Concerns Expressed by Neighbors and Plan Commission

LONG GROVE SENIOR CARE

ILLINOIS ROUTE 53, LONG GROVE, IL

OVERALL SITE PLAN

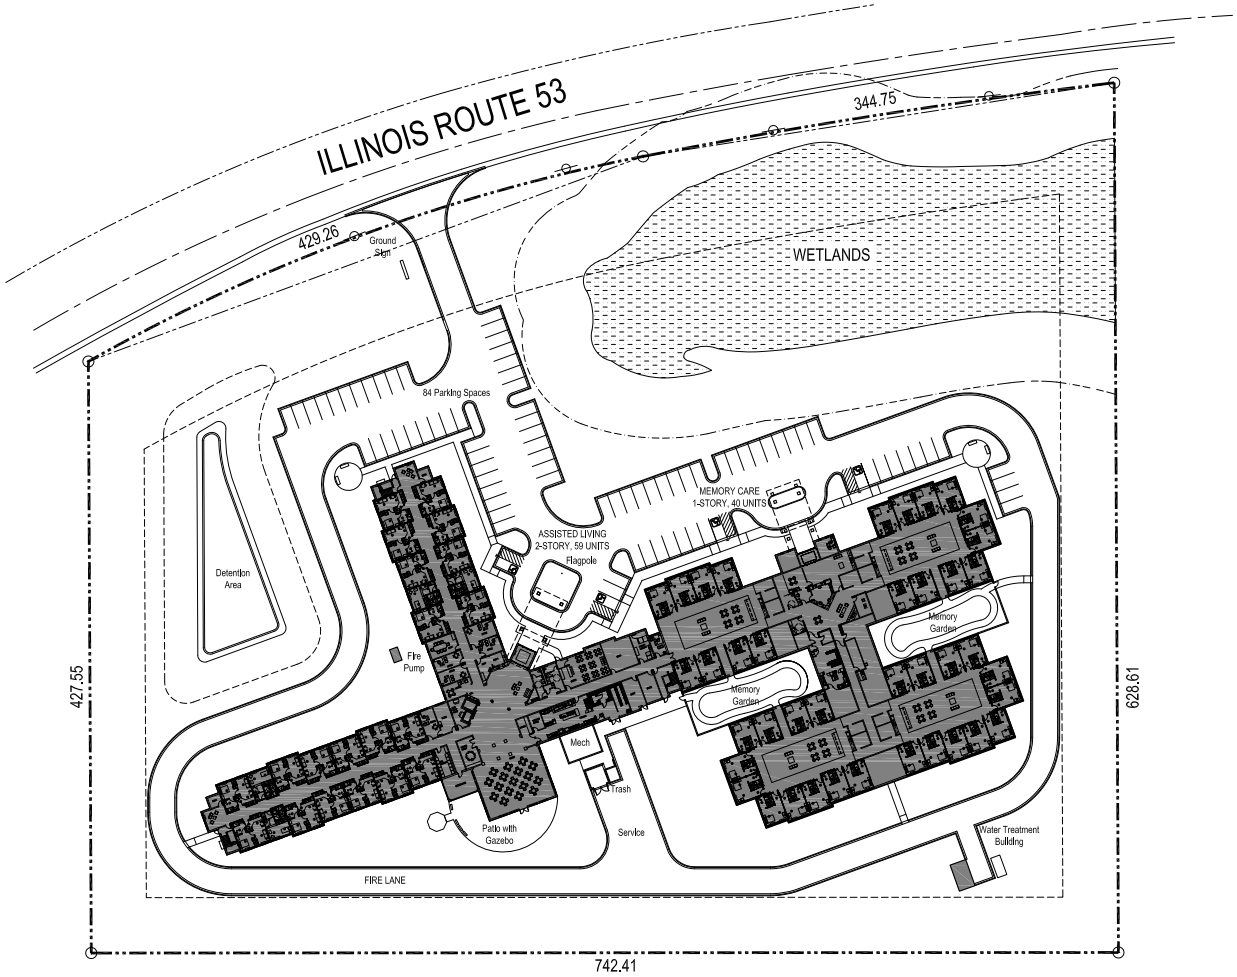
Concern: Too few parking spaces (65)

Response: Parking spaces increased to 84, per Plan Commission recommendation

IL ROUTE 53
PROFILE VIEW OF SITE DISTANCE
RIGHT TURN LANE ACCESS
LONG GROVE SENIOR CARE
ILLINOIS ROUTE 53
LONG GROVE, ILLINOIS
INTERSECTION SITE DISTANCE
VSEI
140314
EXB-2

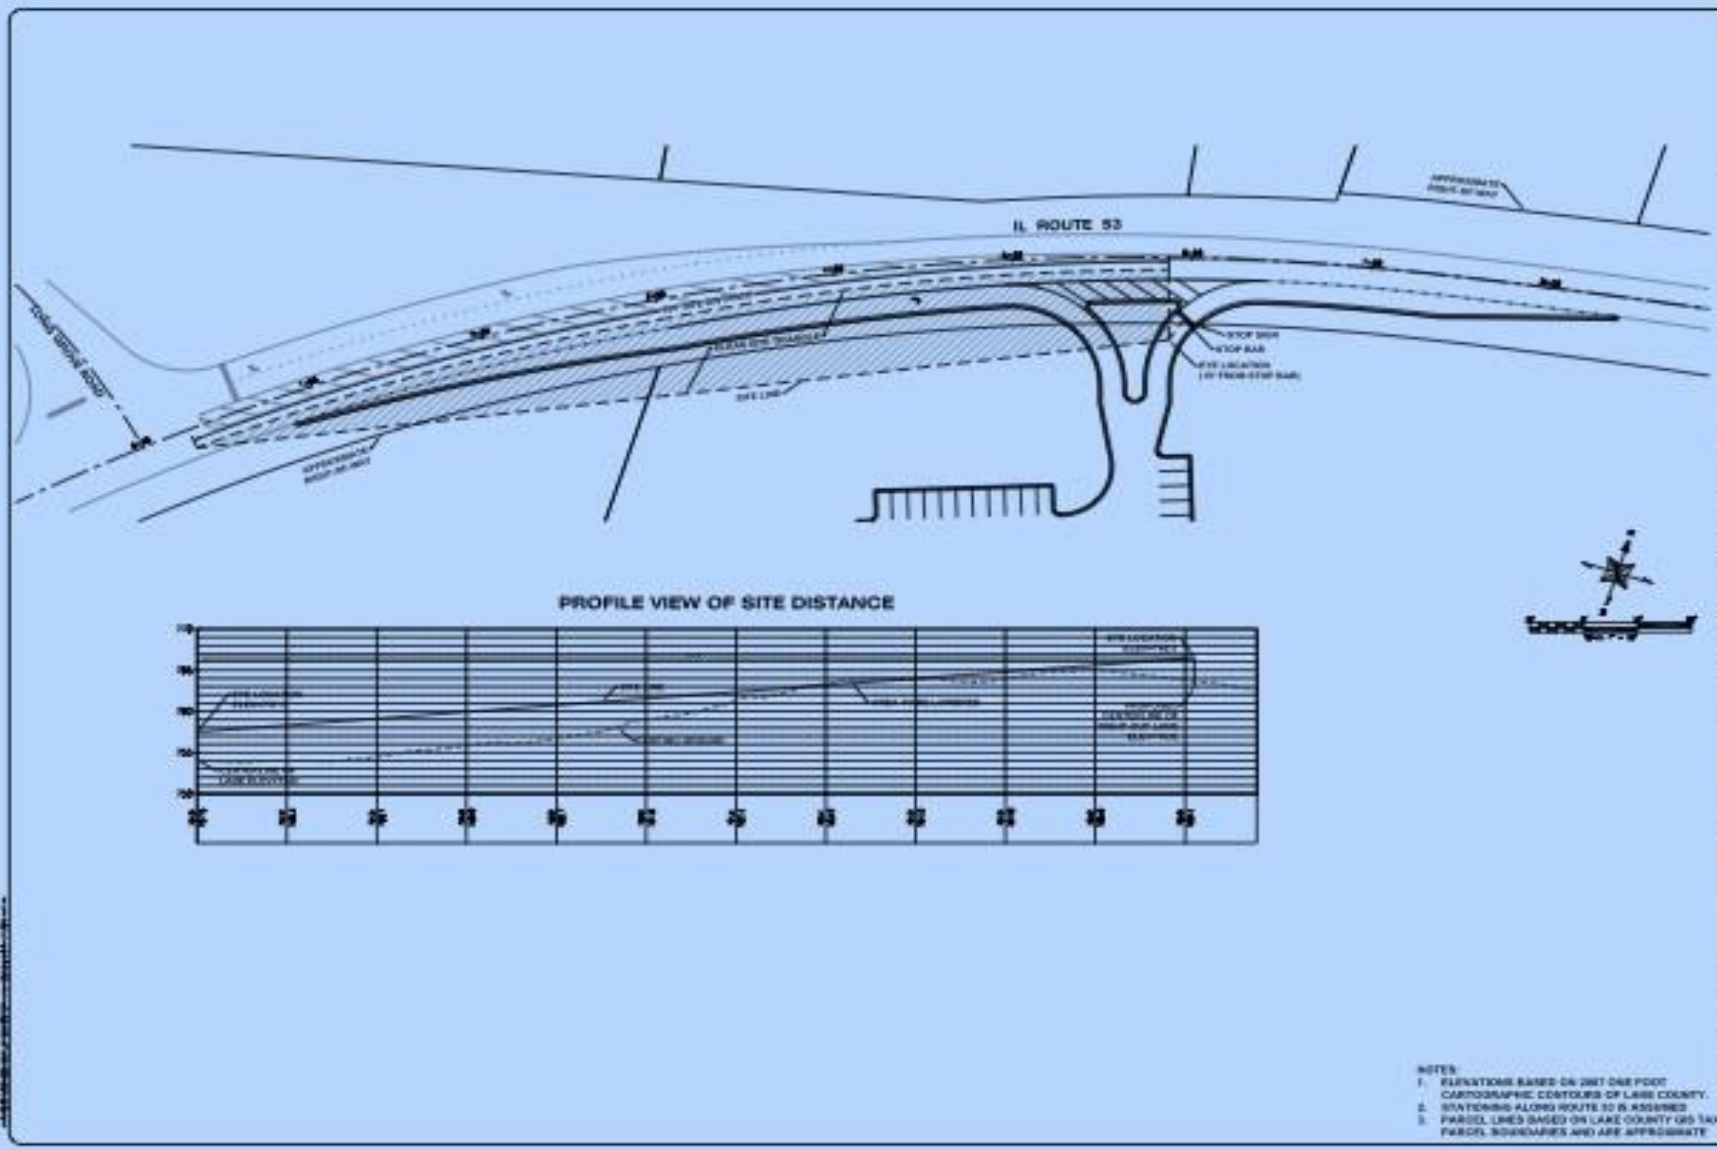
Concern: Safety of left turn in and left turn out, both requiring crossing traffic

Concern: Exiting cars' headlights shining onto properties across RT 53

Response: Access revised: **Right-In /Right-Out ONLY** with deceleration and acceleration lanes

Response: Entry/exit revised to "pork chop" design

POPULATION EQUIVALENT (P.E.) ANALYSIS
LONG GROVE, ILLINOIS
LONG GROVE SENIOR CARE
EXHIBIT

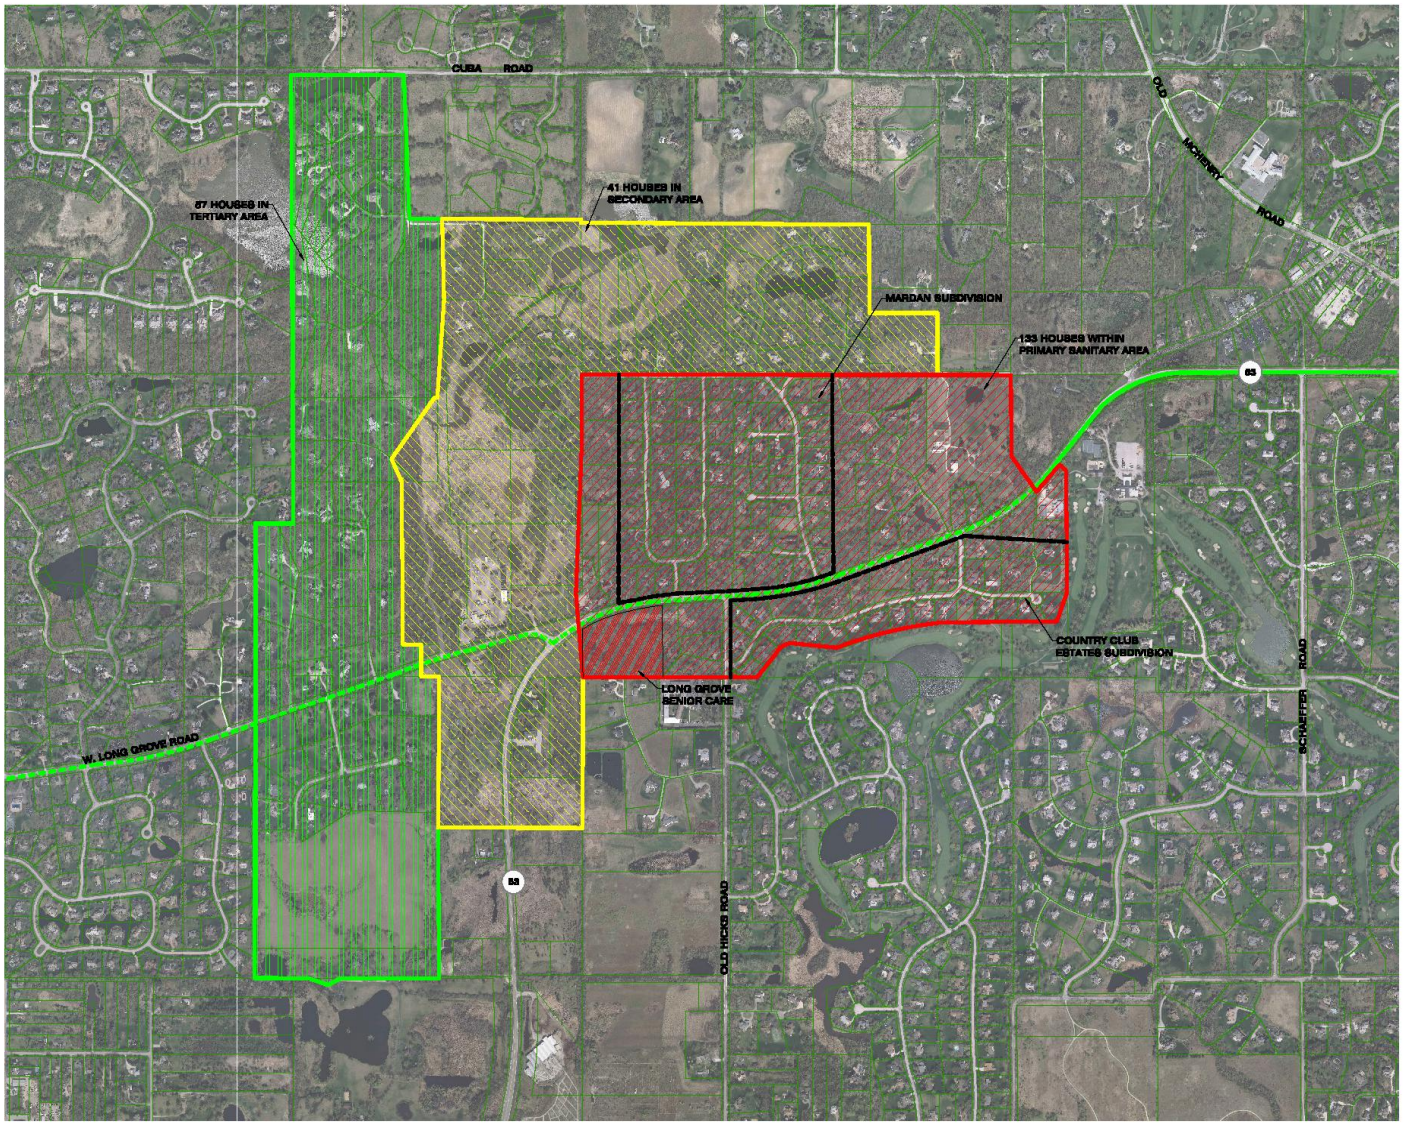
Concern: Sewer capacity for Mardan and Country Club will be used up

Response: Sewer has sufficient capacity for Mardan, Country Club, and LGSC:

Primary Service Area for VLG Reservation:	
2 VLG Homes currently connected (2 X 3.5 PE) =	(7 PE)
131 Mardan & Country Club Homes require (131 X 3.5 PE) =	(459 PE)
Secondary Service Area for VLG Reservation:	
41 Secondary Area Homes =	(144 PE)
Total PE Allocated for Primary & Secondary Areas =	(610 PE)
VLG Reservation in RT 53 Kildeer force-main =	900 PE
Residual PE Available =	**290 PE**
LGSC: 100 LGSC residents + 65 staff/day =	110 PE
Excess PE Available =	**180 PE**

LONG GROVE SENIOR CARE
ILLINOIS ROUTE 53, LONG GROVE
LONG GROVE ILLINOIS
GRADING AND UTILITY PLAN

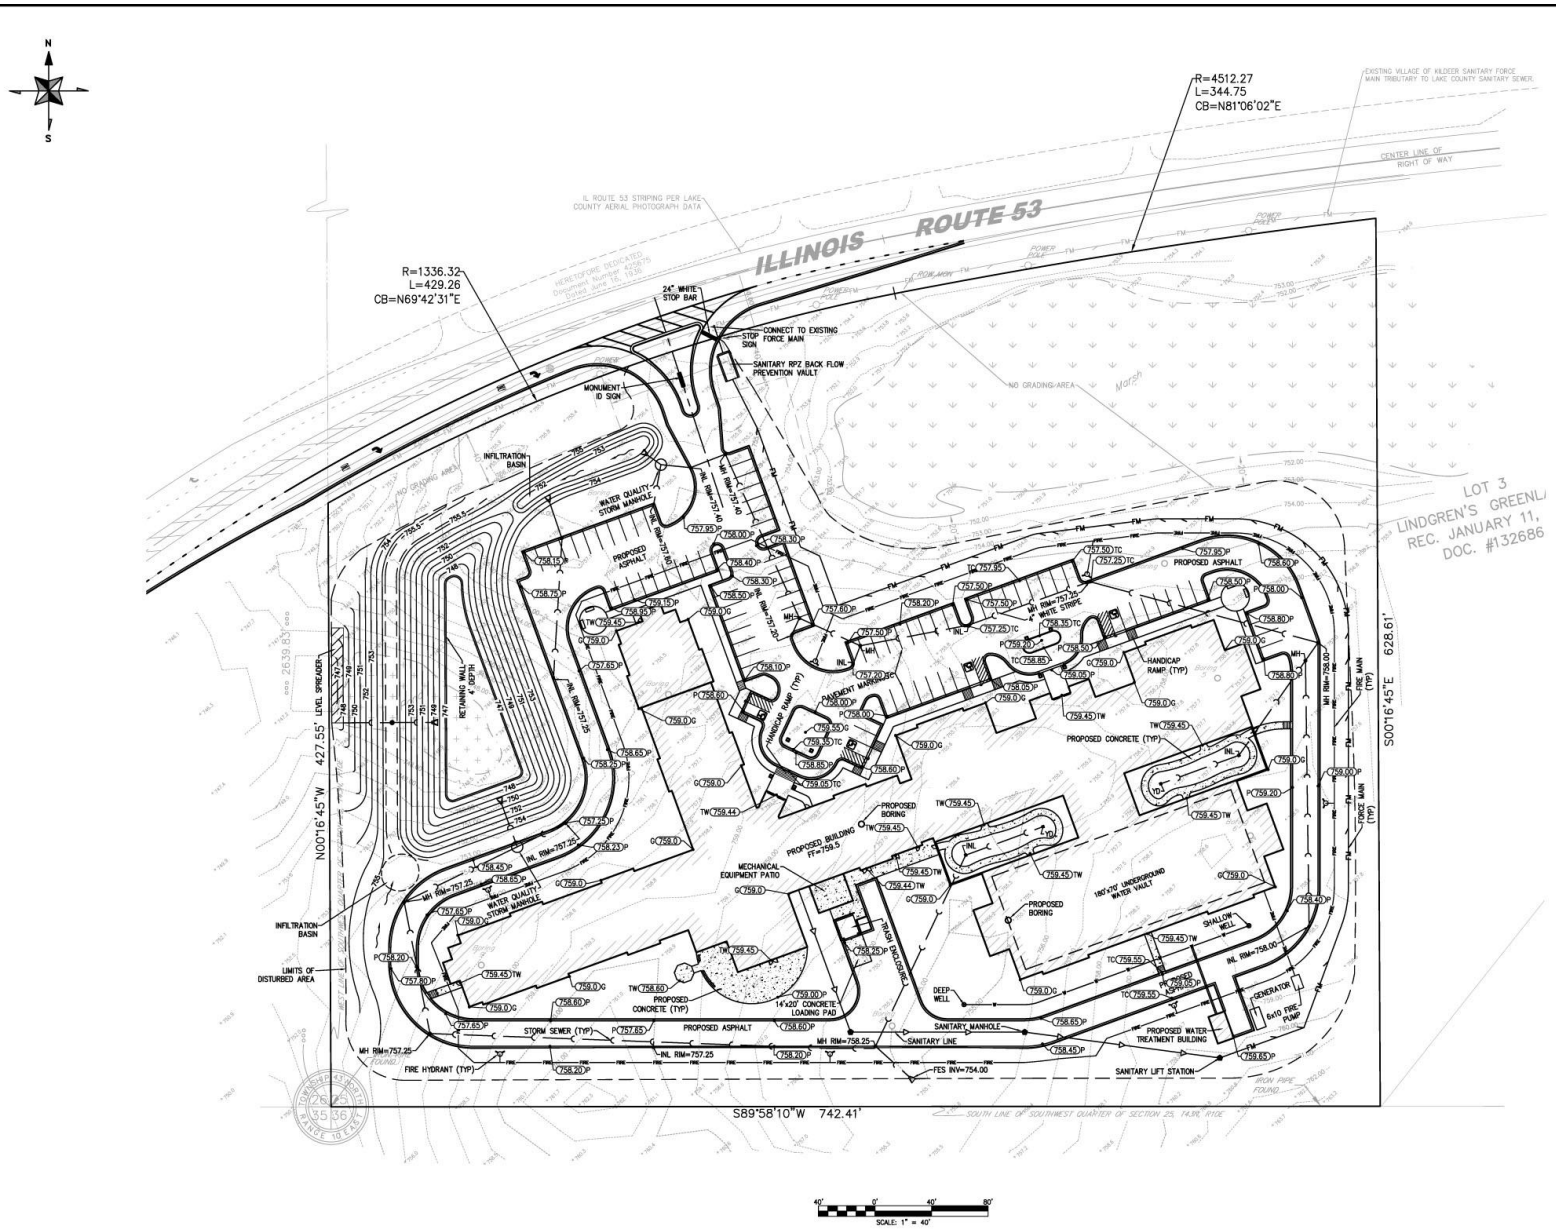
Concern: Storm water from LGSC will flow into Wynncrest

- LGSC Drainage and Grading Plan is designed to preclude water in 100 year storm event from flowing into Wynncrest
- LGSC Drainage and Grading Plan will correct any presently existing 100 year storm event from flowing into Wynncrest
- **LGSC will guarantee no 100 year storm event water flowing into Wynncrest or will pay for restoration**

TREE SURVEY / RETAIL CENTER

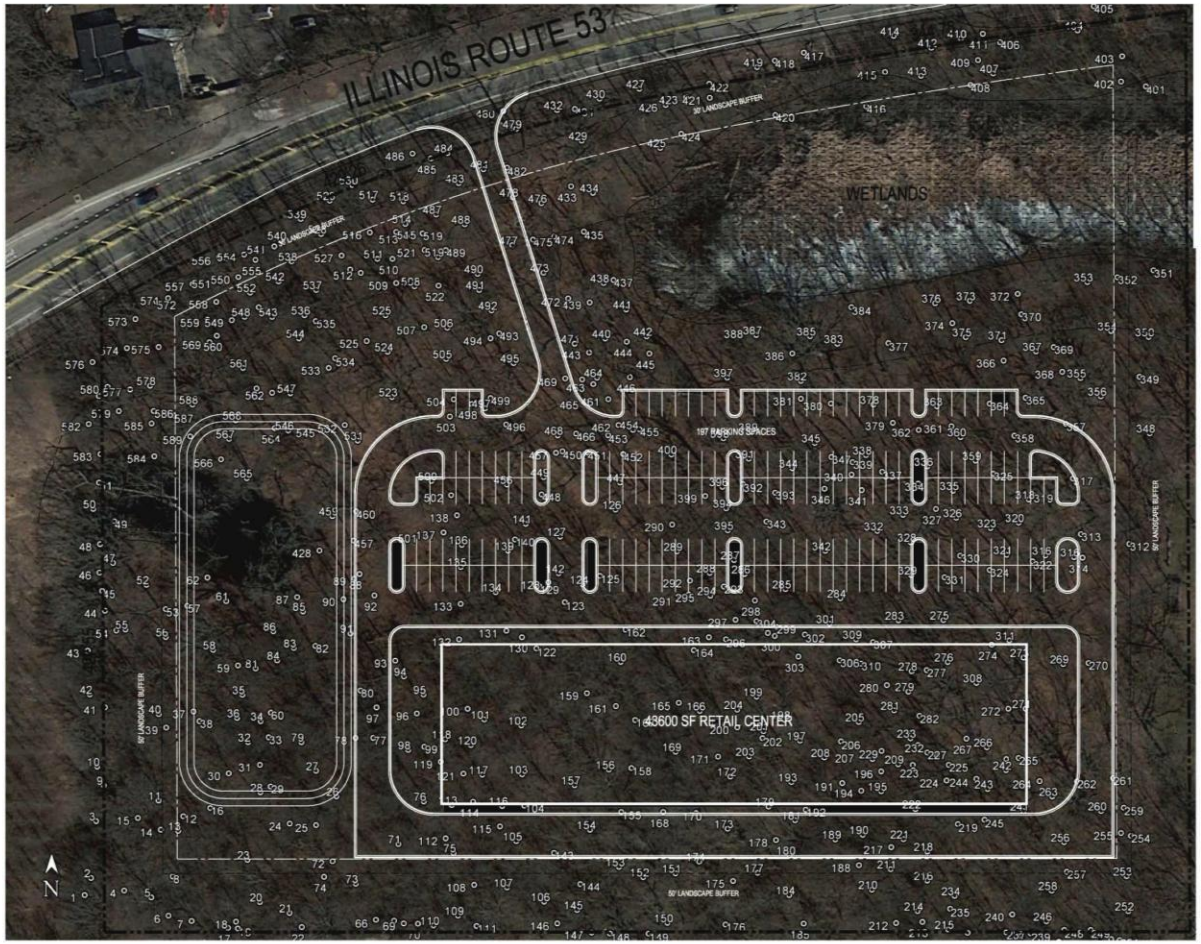
Concern: Retail use would be better use

Response: Retail is not feasible at site

- Retail use would not accept one right-in right-out access/egress
- Retail use would require complete removal of all tree coverage along Rt. 53 to provide full visibility
- Retail use of 40,000sf would require 197 parking spaces
- Retail traffic would be much greater than LGSC and for longer hours
- Retailers uses need to be clustered near other retail uses
- Retail requires bright parking lot lighting to late hours
- Retail requires a large amount of lighted signage at entrance and on building
- Retail generates substantial noise
- Retail requires numerous deliveries and trash removal
- Retail is not in keeping with adjacent uses
- Retail is not allowed in R-2 and would require re-zoning
